2. 450 Green Park, LLC	2 Stone Alley	Addition	42.3.1-102	LINK
------------------------	---------------	----------	------------	------

JOB LOCATION:
2 STONE ALLEY
NANTUCKET, MA
EAST & WEST ELEVATIONS

2 Stone Alley

Revisions - August 2020

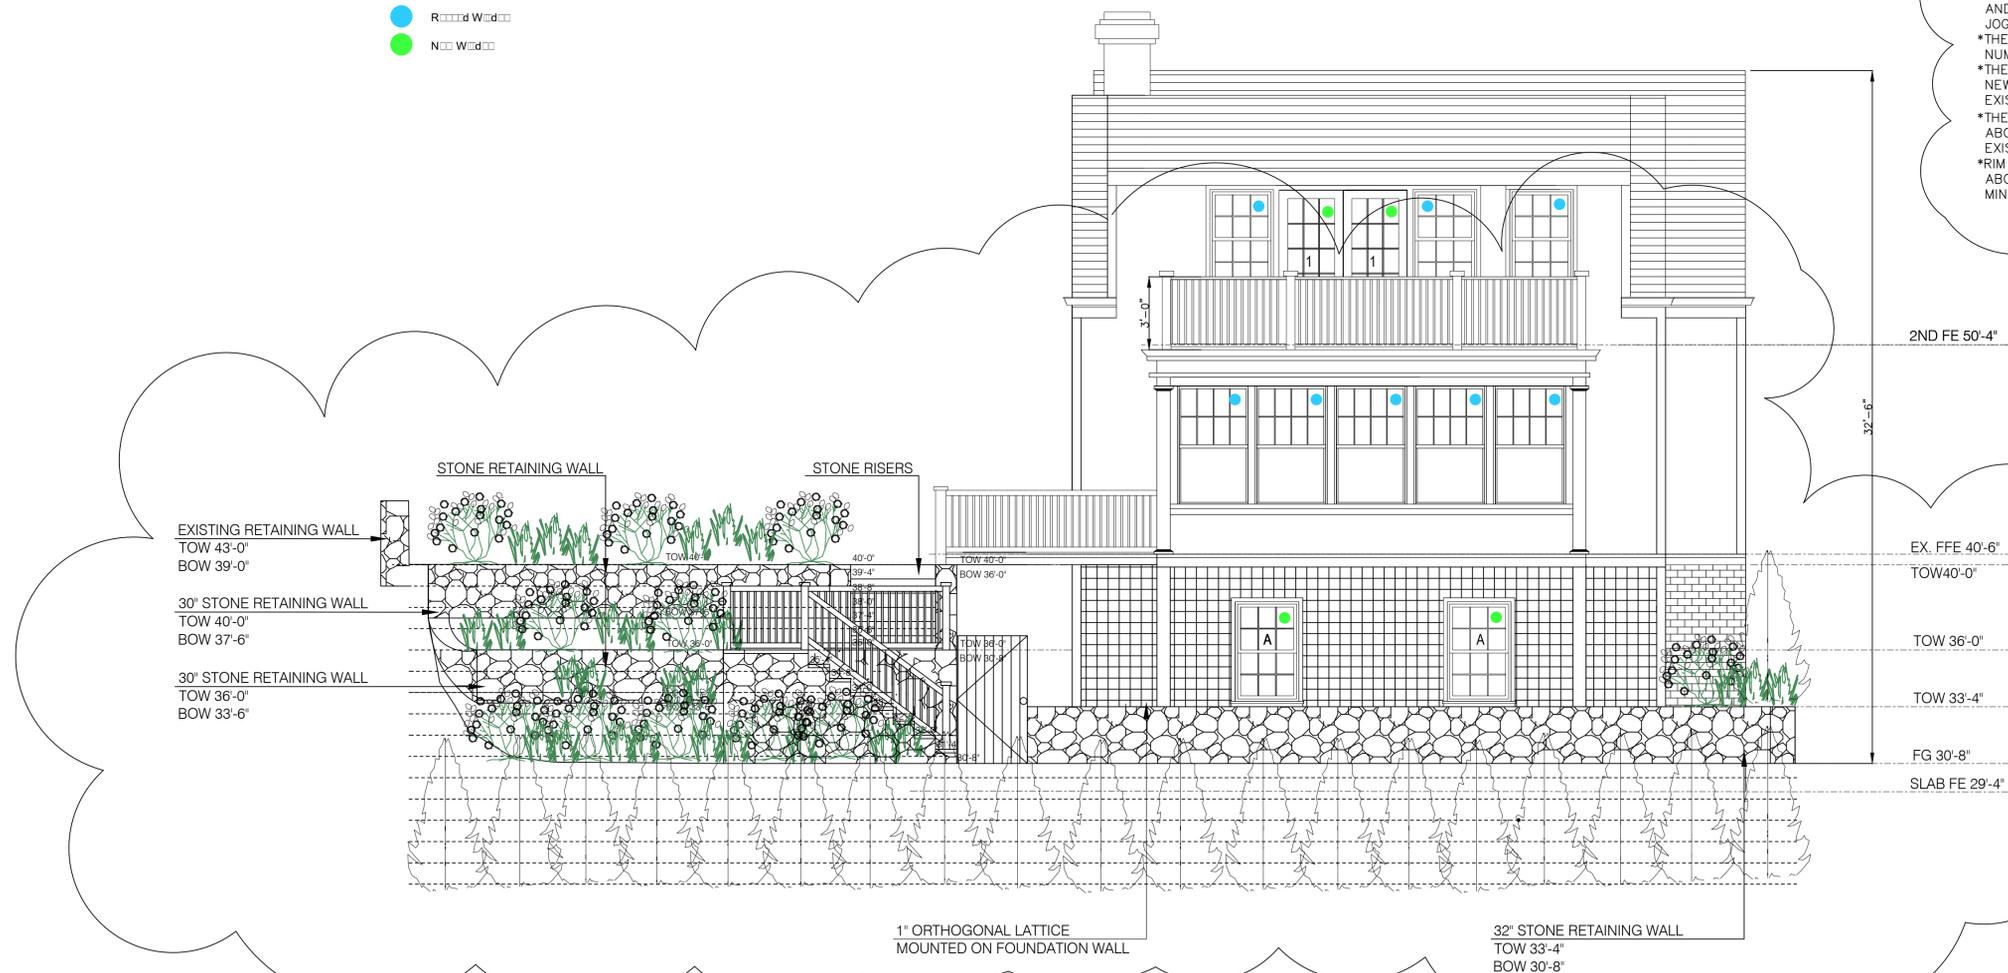
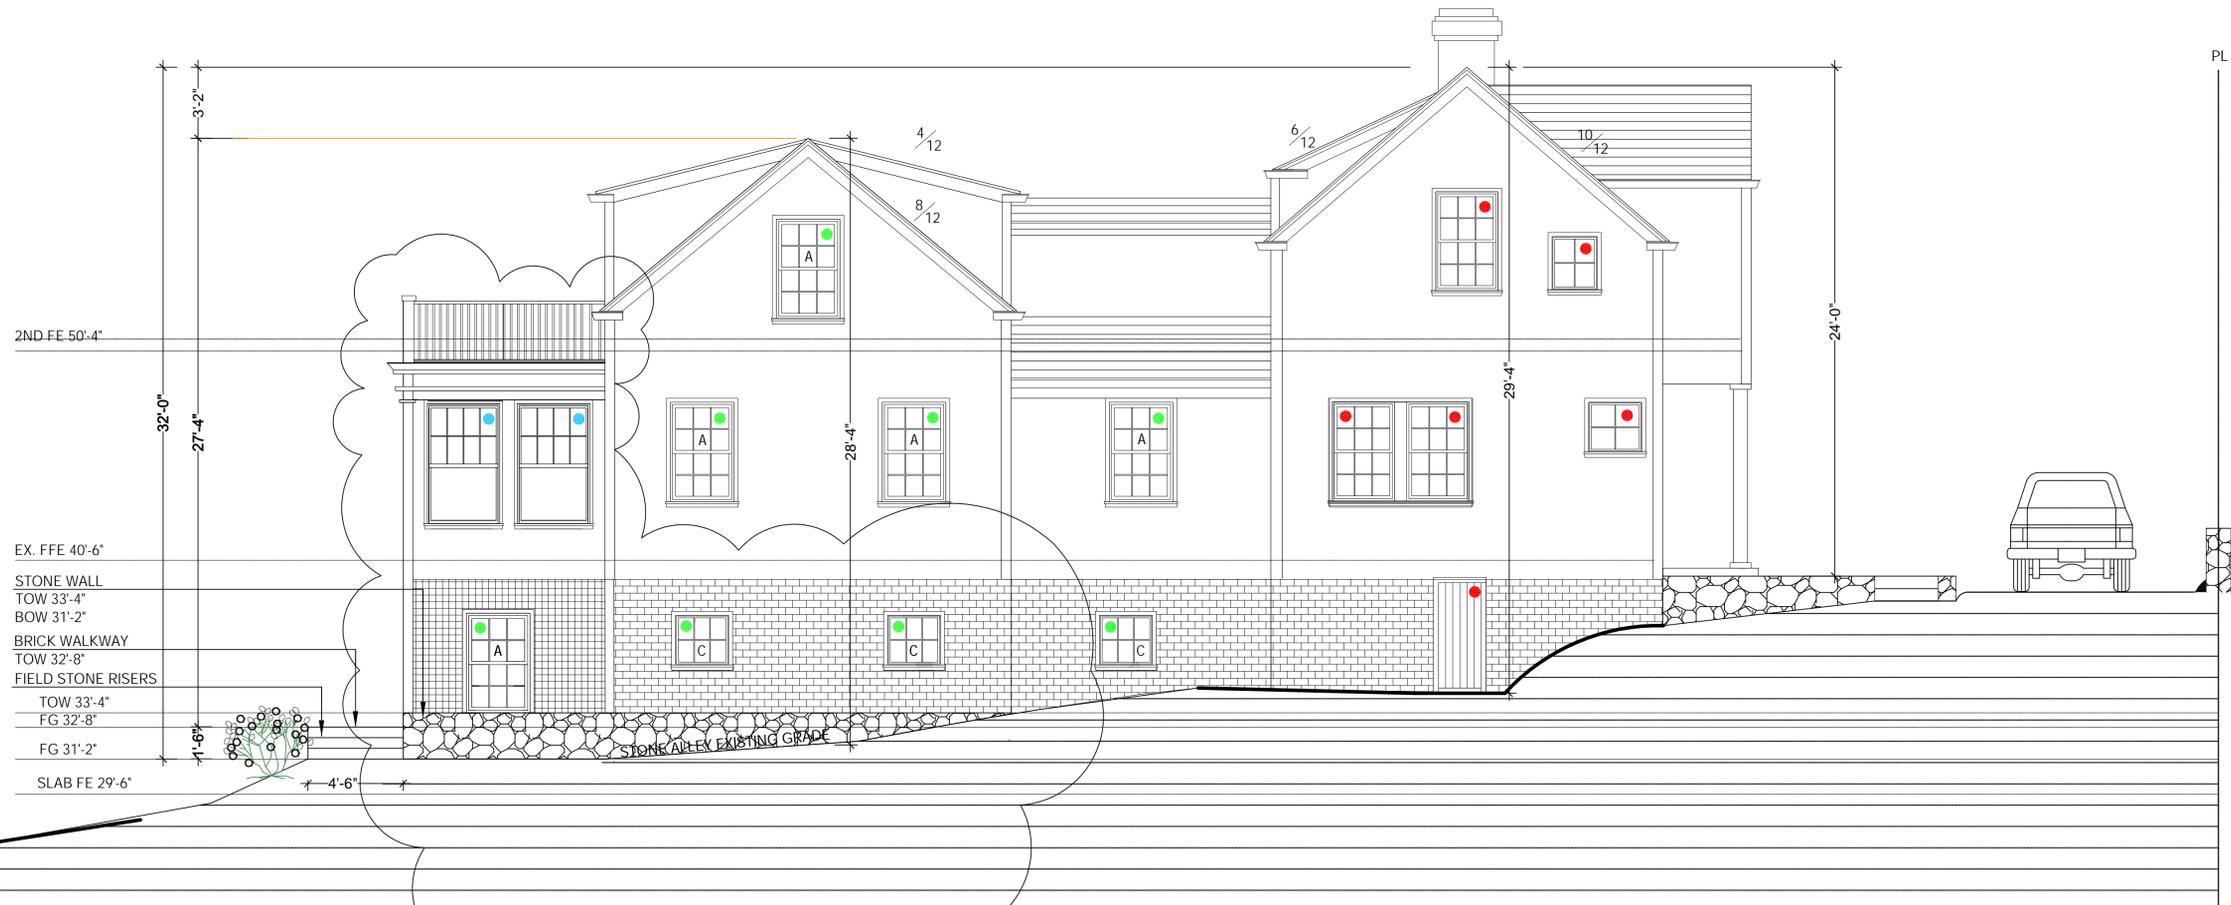
Welch – First and foremost, regards the discussion we've been having about the shift to the south; to be acceptable this has to happen. The connector and secondary mass are too close to Stone Alley historic setting. The applicant's agent has mentioned the applicant's perception of modifications and being sensitive however there is a difference between the applicant's perception of their design conformance to-date, and their actually being receptive to HDC concerns—we've not gotten much traction with HDC concerns addressed. Confirmed through applicant's agent that addition segments along Stone Alley have not been moved any further away. East elevation, there is a discrepancy that does not represent the jog between the existing structure, the proposed additions and the dormer and as drawn on the proposed plans; the covered porch corners and trim details need to replicate the existing exactly; the proportion of window height to the wall is different, too much at approximately 3' vs. 1' existing and this needs to be addressed; porch window bays should be

reduced by at least 2, which pulls the porch addition away from Stone Alley by making it narrower, which necessitates changing 2nd-floor windows adjusted to align accordingly. Not redesigning, simply illustrating types of concepts that are appropriate to him. Provided examples of other concepts: South elevation, the height of the secondary gable needs to read as purely secondary to the main structure which can be accomplished by decreasing the width, which also lowers the height; doors on the 1st floor are 7'6", which can be decreased North elevation, comments on width and height and porch trim details stand; rim board header at the dormer windows and doors would allow a decrease in height. If the addition has to be a shift south and east, that could make a dramatic difference.

D. The proportion of window height to the wall is different, approximately 3' vs. 1' on existing

E. Porch window bays should be reduced by at least 2, which pulls the porch addition away from Stone Alley by making it narrower

- *THE DISCREPANCY BETWEEN THE EAST ELEVATION AND THE PLANS AS FAR AS THE LOCATION OF JOGS IN THE ELEVATION HAS BEEN CORRECTED
- *THE PORCH HAS BEEN REDUCED AND THE NUMBER OF WINDOW BAYS
- *THE HEIGHTS OF RIDGES HAVE BEEN REDUCED ON NEW ADDITION TO BE SECONDARY TO THE EXISTING STRUCTURE
- *THE TRIM DETAILS OF THE NEW PORCH ROOF ABOVE WINDOWS HAVE BEEN CORRECTED TO EXISTING EXACTLY MATCH ORIGINAL EXISTING
- *RIM BOARD HEADERS HAVE BEEN EMPLOYED ABOVE DORMER WINDOWS AND DOORS TO ASSURE MINIMUM HEIGHT OF THE NEW ROOFS

- We have corrected the drawings in this submission to properly depict porch details to meet the HDC's request (See East Elevation Plan Page A5).

- We have corrected the drawings in this submission to properly depict window height to wall proportion to meet the HDC's request (See East Elevation Plan Page A5)

- We have reduced the porch window count by two windows so that the porch repurposes existing windows only to meet HDC's request (See East Elevation Plan Page A5).
- This window reduction has once again reduced the structure's east fenestration.
- East fenestration is in keeping with the neighborhood (See Slides 30-42)

Pohl – He is certain the maximum ridge height on one side, which is measured 4 feet away from the wall, exceeds the allowed zoning height on the north and south side; he checks that every time this comes in and no change has been made. Supports moving this more south. The foundation plan shows the wall 1-foot thick that doesn't allow for a veneer over the concrete. This addition is too tall because it is being built on a precipitous slope.

B. The maximum ridge height on one side (measured 4 feet away from the wall) exceeds the allowed zoning height on the north and south side.

- We've updated drawings to better reflect the North wall wrapping around to the east side of the house at the existing grade which brings all ridge heights within guidelines. (See North Elevation Plan Page A7)
- The average height of the house remains below average height of neighboring properties and in keeping with the neighborhood (See Slide 16).

JOB LOCATION:
2 STONE ALLEY
NANTUCKET, MA
SOUTH ELEVATIONS

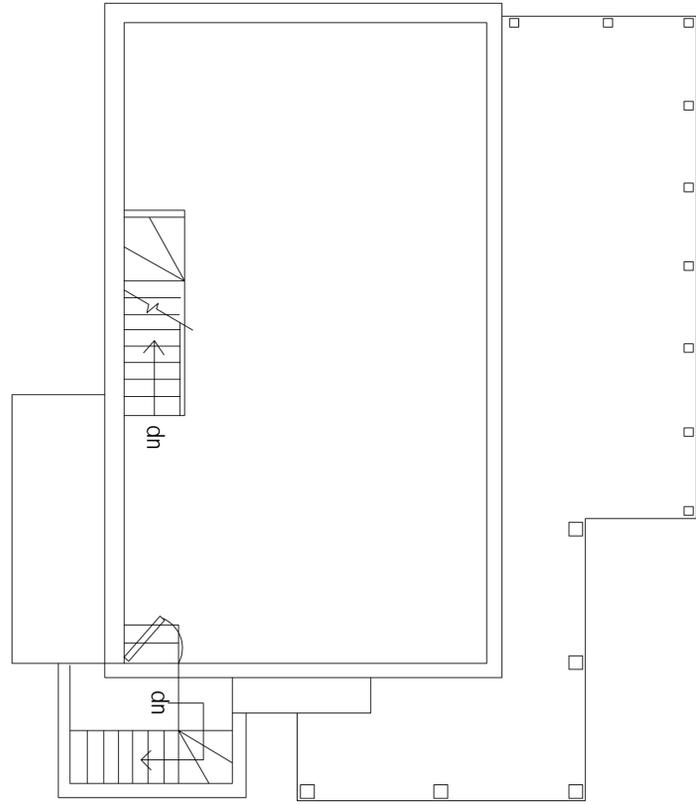
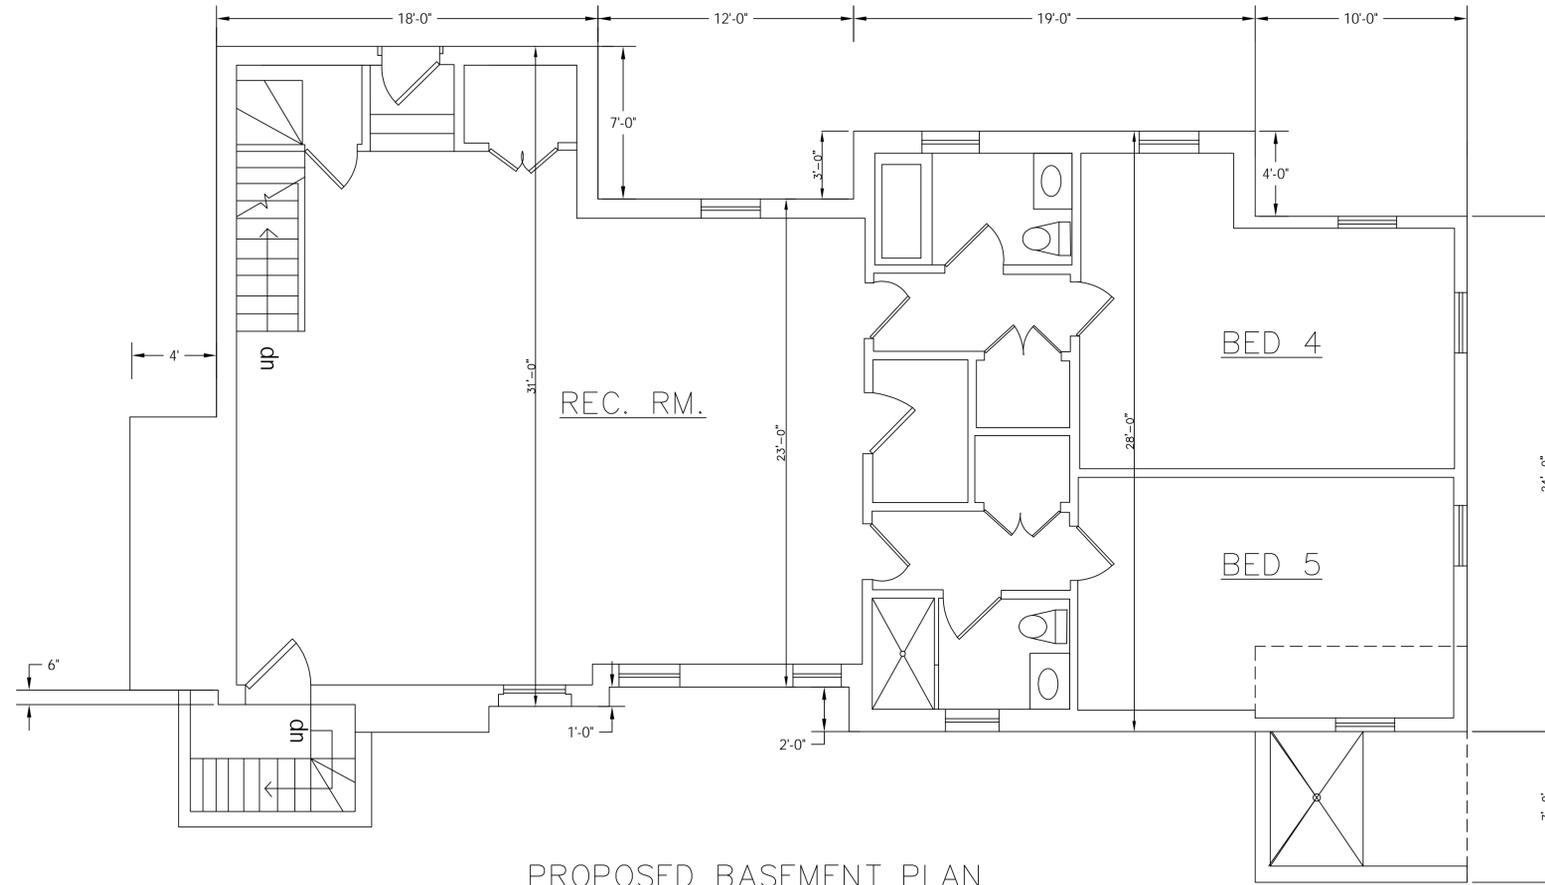
F. On the South elevation the height of the secondary gable needs to read as purely secondary to the main structure

- These revised drawings better represent the details of the secondary gable, which shows that it is secondary to the main structure. (See South Elevation Plan Page A6).
